LOW & MEDIUM PROFILE HATCH Mk1 & Mk2 IDENTIFICATION

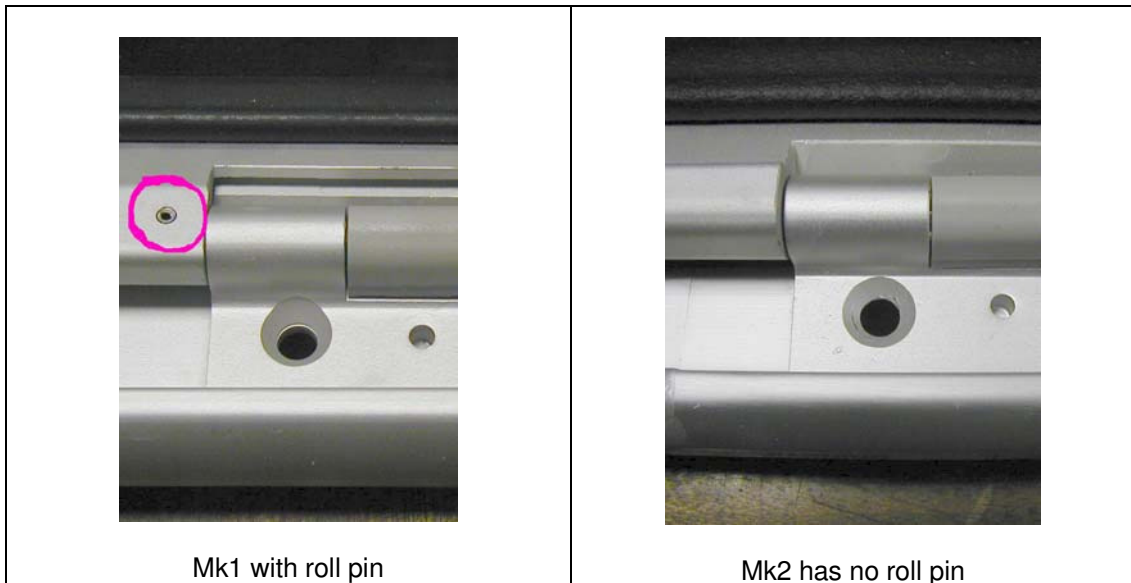
The Low & Medium Profile Hatches changed from Mk1 to Mk2 version between July and December 2000

On Mk1 hatches a roll pin is visible on the underside of the lid near the hinge.
There is no roll pin on Mk2

All Low & Medium Profile hatches have a lens code
Standard sizes of Mk1 hatches have a code that starts 399....
Standard sizes of Mk2 hatches have a code that starts A399...
